# Zonnequa Wind Farm, Northern Cape Province

Motivation for amendment of Environmental  
Authorisation

DEA Ref.: 14/12/16/3/3/1/1970

October 2019

**Figure 2.1:** Proposed amended Zonnequa Wind Farm layout map (A3 Map included in **Appendix I**).

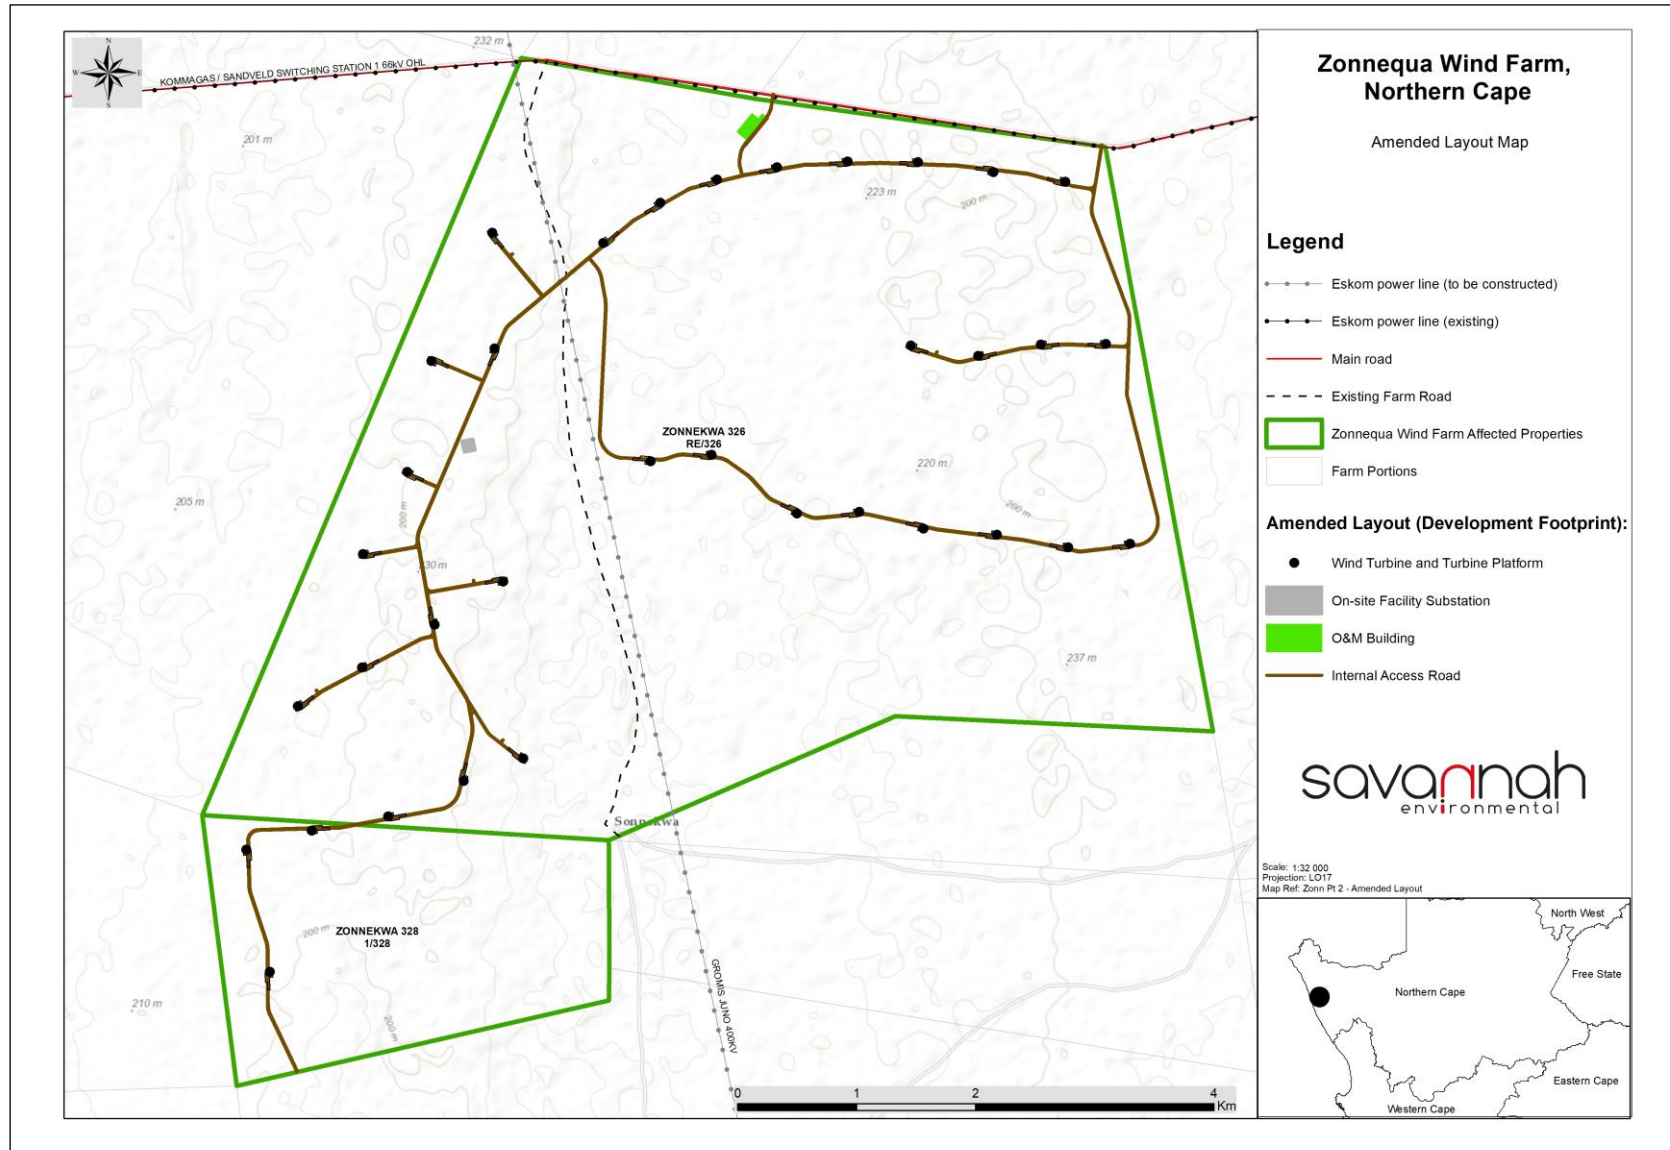
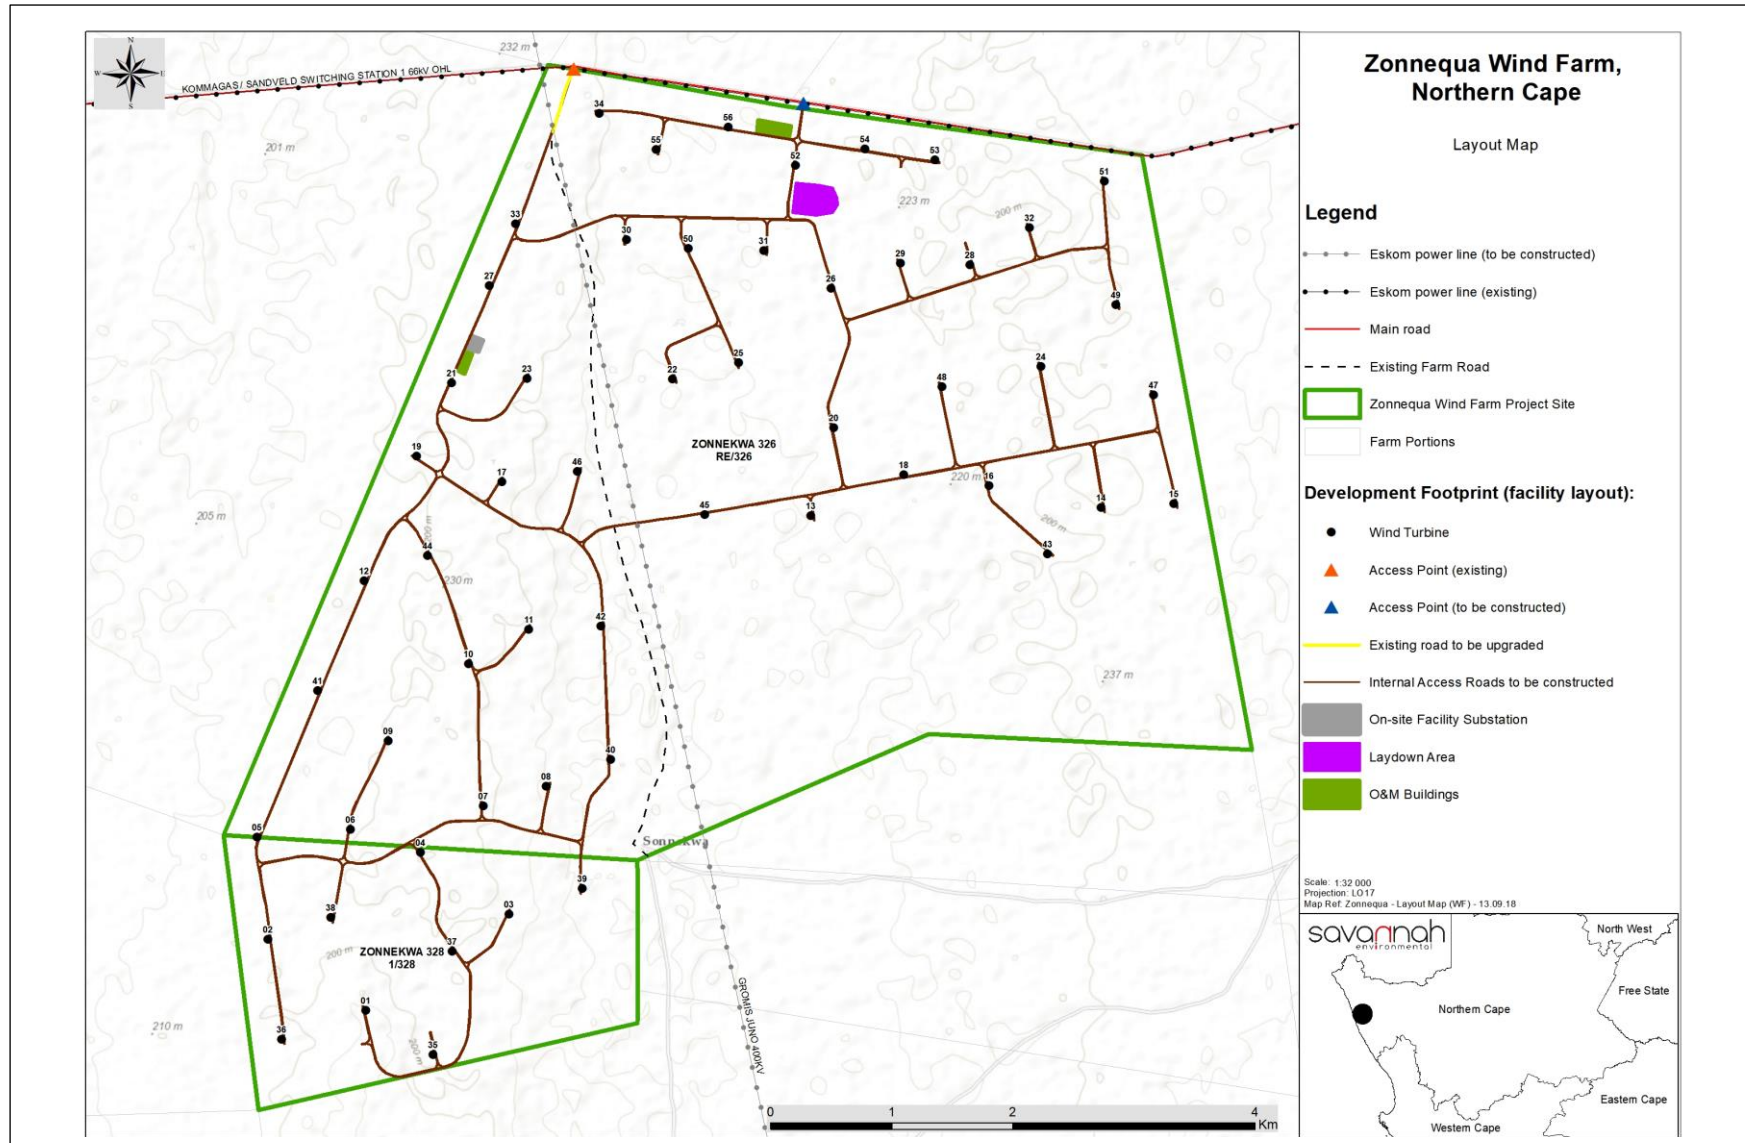
The proposed amended layout is presented in **Figure 2.1**. The layout was provided to the specialists for assessment and input in terms of the suitability of the layout for implementation and the identification of additional mitigation measures (if required). **Figure 2.2** includes the layout as was assessed during the BA process and included in the final BA Report submitted to DEFF for decision-making on the application for EA.

It must be noted that this amended layout is submitted to DEFF for review and approval in accordance with Condition 13 of the EA.

**Figure 5.1:** Updated bat sensitivity map that must be adhered to for the development of the Zonnequa Wind Farm amended layout

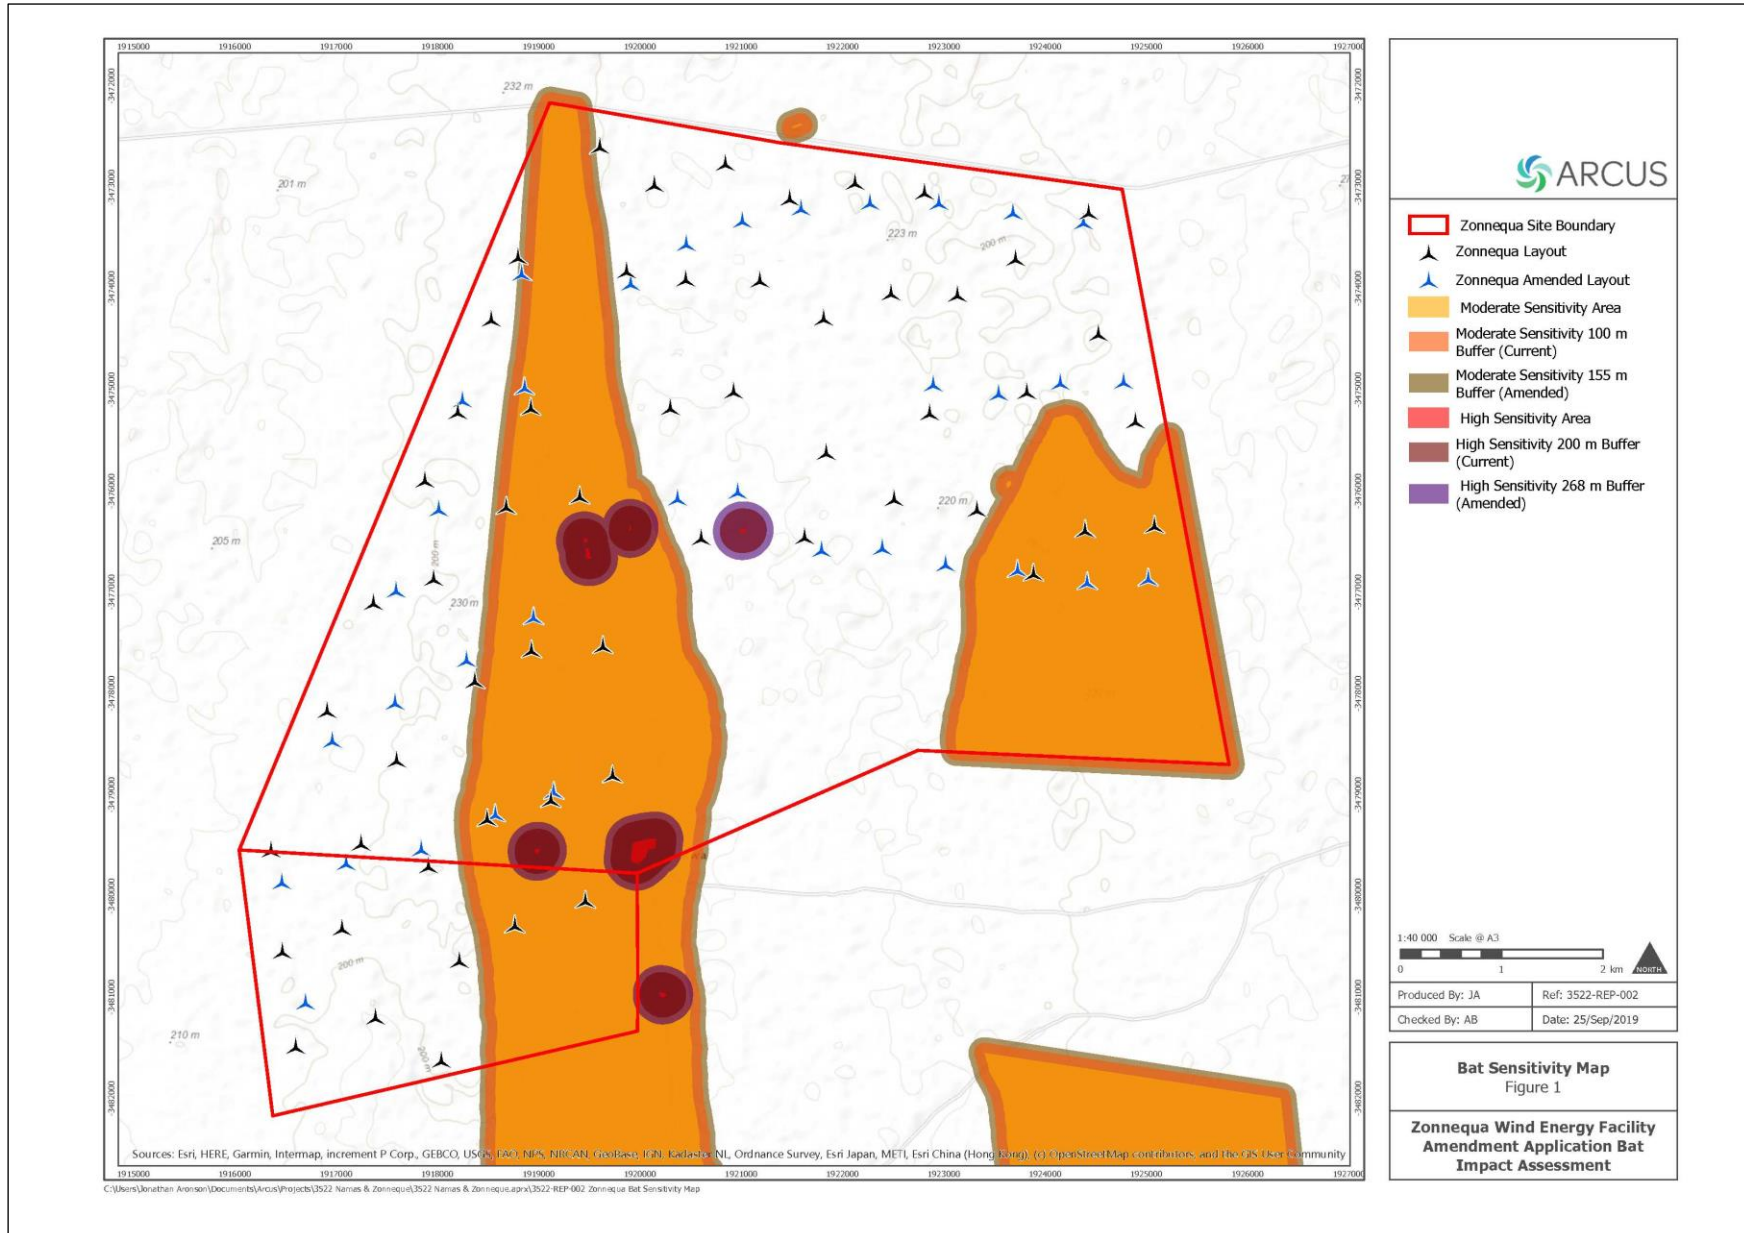
Considering the Bat Impact Assessment and the proposed amendments to the turbine dimensions, it is not expected that the amendments will result in an increase in the overall bat impacts. Cumulative mortality impacts would also not increase beyond what was previously identified, assessed and rated. However, there may be additional impacts to high flying species because the blade tips will extend higher into the air. Risks to lower flying species may be reduced as the blades will be higher above the ground.

The key mitigation measure that should be implemented at the Zonnequa Wind Farm would be adherence to the updated sensitivity map (**Figure 5.1**). The sizes of the bat buffers have been increased to reflect the changes in the turbine size. An additional mitigation measure recommended by Animalia (2018) is that curtailment via blade feathering (90-degree feathering below the manufacturer's cut in speed) must be applied to all turbines from sunset until sunrise every night during March, April, May, August and September. The requirements of curtailment and blade feathering and the application thereof, as contained in the EMPr and contained in the Bat Impact Assessment by Animalia 2018, still apply and no changes to this have been made based on this assessment. Operational monitoring must also be carried out as per best practise (i.e. for a minimum of two years) and based on these results, adjustments to the curtailment may be needed or the use of acoustic deterrents investigated. If these mitigation measures are adhered to, the specialist accepts the proposed amendments.

- » The key mitigation measure that should be implemented at the Zonnequa Wind Farm would be adherence to the updated sensitivity map (Figure 5.1 of section 5).<sup>7</sup>

**Figure 5.2:** Zonnequa Wind Farm amended layout overlain with the ecological sensitivity of the project site

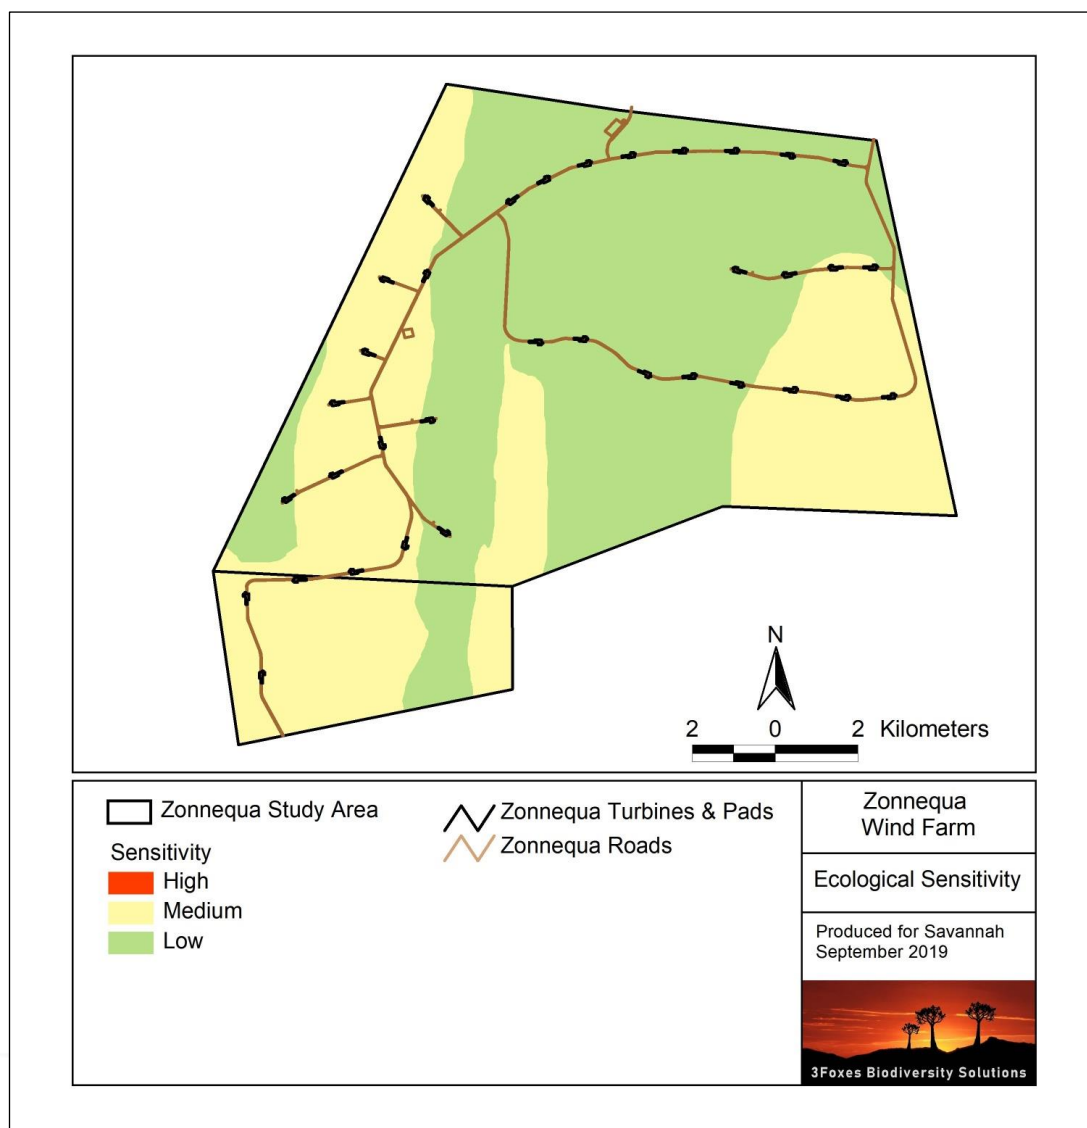
The specialist has considered the proposed amended layout and the ecological sensitivity of the project site. The ecological impact of the amended 35 turbine layout is likely to be somewhat lower to the original 43 turbine layout as a result of the reduced number of turbines and access road footprint associated with the amended layout (**Figure 5.2**). No new impacts are expected to occur with the implementation of the amended layout.

The total footprint of the wind farm would be reduced but this is not considered sufficient to change the overall ecological impact of the amended layout as compared to the original layout assessed in the BA process. The larger turbine size is not considered to be of consequence with regards to terrestrial impacts as, while the turbine hard stand may be larger for each turbine, the reduction in the number of turbines would compensate for any increase in footprint associated with each turbine.

**Figure 5.3:** Comparative viewshed analysis for the layout assessed as part of the BA process and amended layout of the Zonnequa Wind Farm

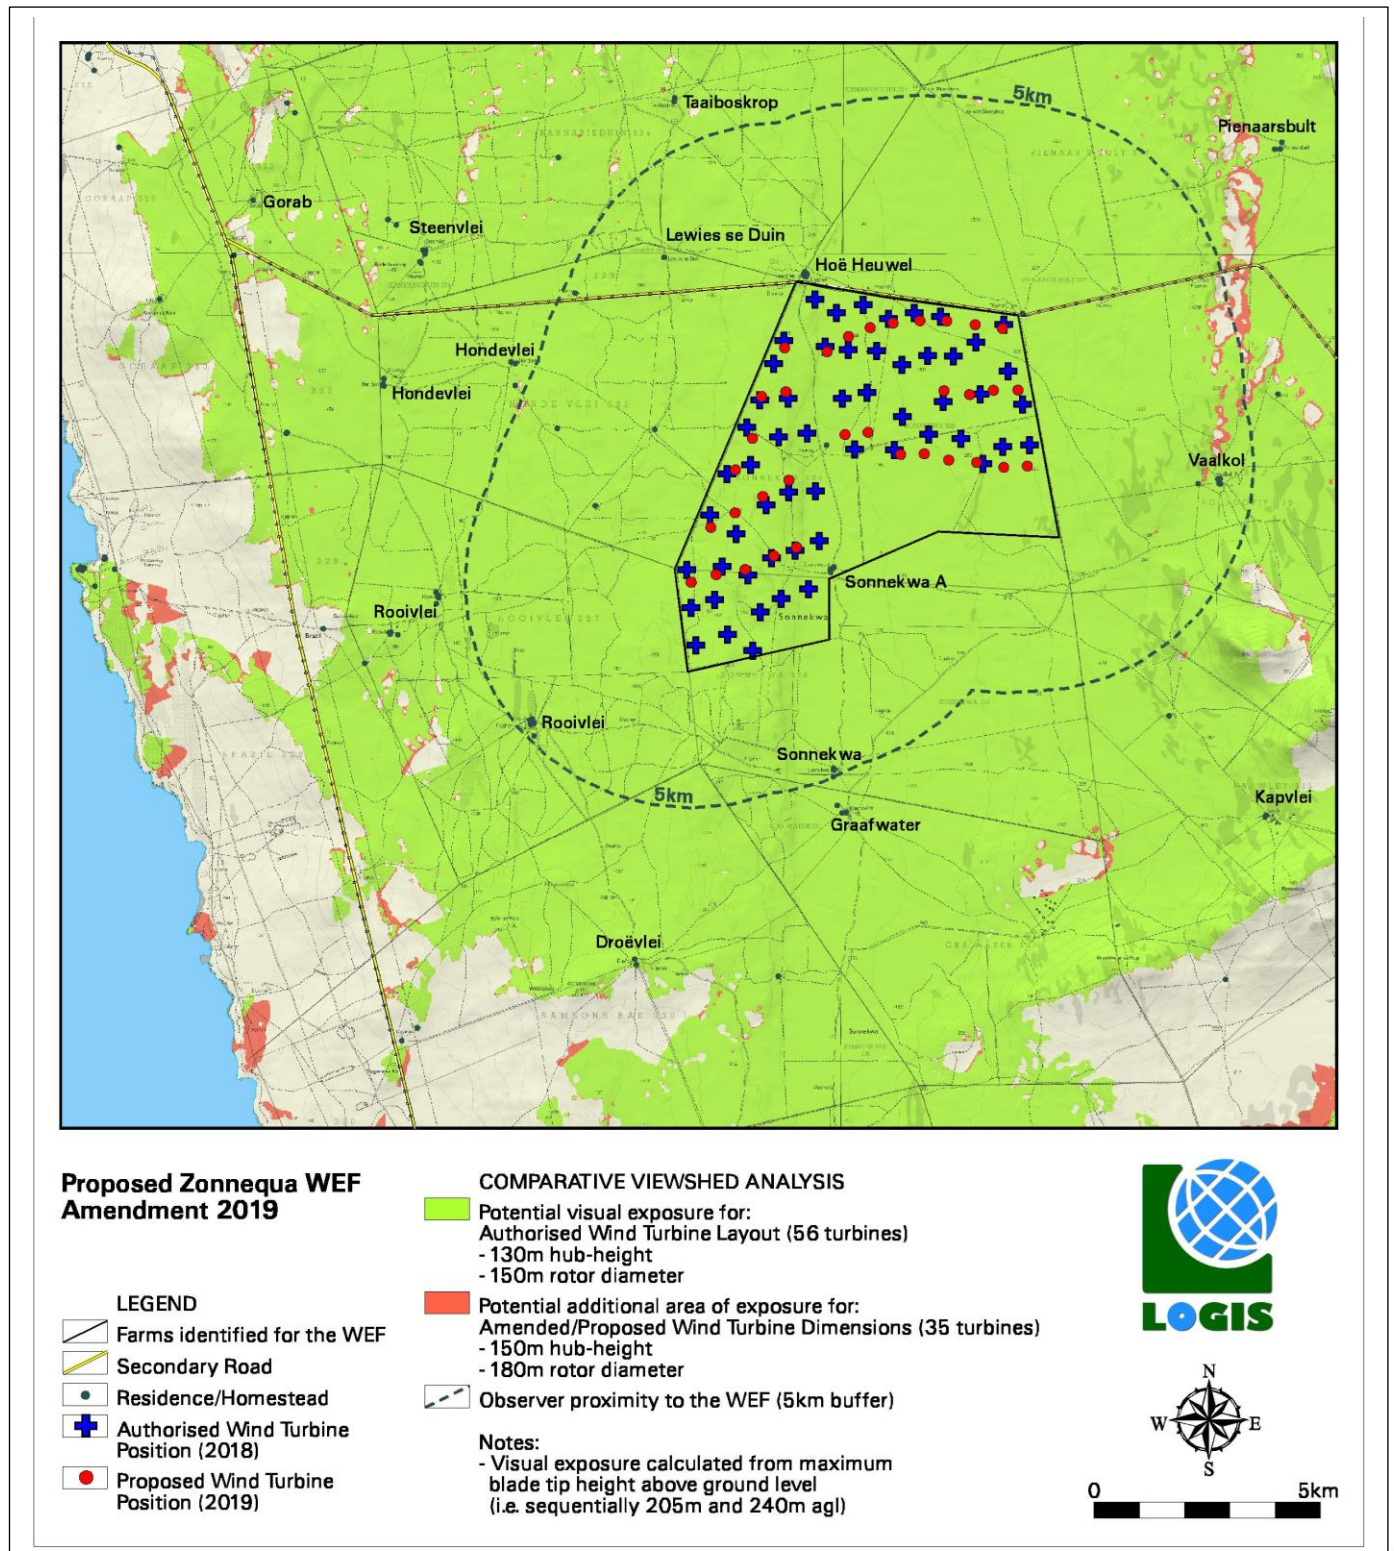
A viewshed analysis was undertaken from each of the authorised wind turbine positions (56 in total) at an offset of 205m (maximum tip height) above ground level. The result of this analysis represents the potential total visual exposure of the original and authorised turbine dimensions (indicated in green in **Figure 5.3**). The viewshed analysis was repeated at an offset of 240m to indicate the visual exposure (shown in orange in **Figure 5.3**) of the increased turbine dimensions and reduced number of turbines (35 in total) proposed as part of the amendment.

The increased area of visual exposure does not include a significant portion of additional exposure to the secondary roads within the area. In spite of the reduction in the number of turbines it is expected that the wind turbine structures, both the original dimensions and the proposed increased dimensions would be equally visible and noticeable from both the roads and homesteads identified above. This signifies a negligible change to the potential visual impact with the implementation of the increased turbine dimensions and amended layout.

Through the consideration of the proposed amendments, the specialist has indicated that there will be no change to the visual impacts and the significance ratings of the impacts. The reduction in the number of turbines is expected to reduce the frequency of visual exposure to some extent, although the remaining 35 (larger) turbines are expected to remain visible within a 5km radius of the Zonnequa Wind Farm.
